HISTORIC AND DESIGN REVIEW COMMISSION

HDRC CASE NO: 2023-250
ADDRESS: 434 ADAMS ST
LEGAL DESCRIPTION: NCB 2879 BLK 4 LOT 18 S 15 FT OF 16
ZONING: RM-4, H, HL
CITY COUNCIL DIST.: 1
DISTRICT: King William Historic District
APPLICANT: Jake Dady /DADY JACOB MATTHEW
OWNER: Jake Dady /DADY JACOB MATTHEW
TYPE OF WORK: Conceptual approval of a two-story accessory structure
APPLICATION RECEIVED: May 31, 2023
60-DAY REVIEW: July 30, 2023
CASE MANAGER: Jessica Anderson

The applicant requests conceptual approval for construction of a two-story accessory structure.

DADY RESIDENCE

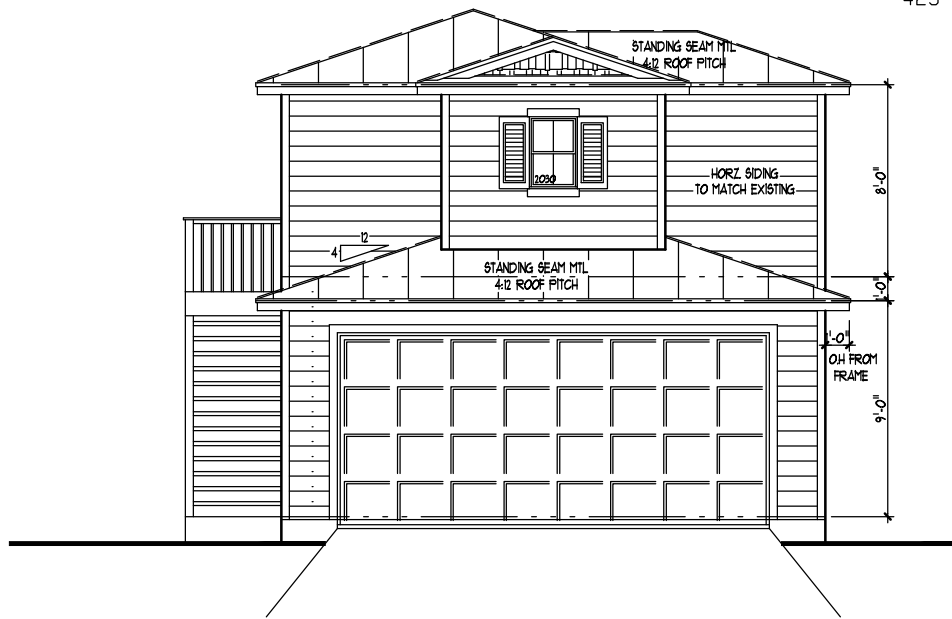
- g. **WINDOWS (RELATIONSHIP OF SOLIDS TO VOIDS):** The applicant proposes a two-over-two window on the second floor of the south elevation, but did not provide elevations for the other sides of the structure. In plan, the second floor of the proposed accessory has one window on the north elevation and one on the east elevation. Historic Design Guidelines for New Construction 2.C.1 says to incorporate window and door openings with a similar proportion of wall to window space as typical with nearby historic facades. Staff finds that the applicant should incorporate windows on the west elevation.

- h. **GARAGE DOOR:** The applicant proposes a two-bay garage door for the south elevation of the accessory structure. Guidelines for New Construction 5.B.v says to incorporate garage doors with similar proportions and materials as those traditionally found in the district. Staff finds that the two-bay garage door is not consistent with the guidelines, and that the applicant should propose a split-bay garage door.

- iv. That the applicant proposes a window product that conforms to standard specifications for windows in new construction, namely a high-quality wood or aluminum-clad wood window product with a two-over-two configuration.
- v. That the applicant incorporates additional windows on the west elevation of the second floor.
- vi. That the applicant proposes a split-bay garage door.
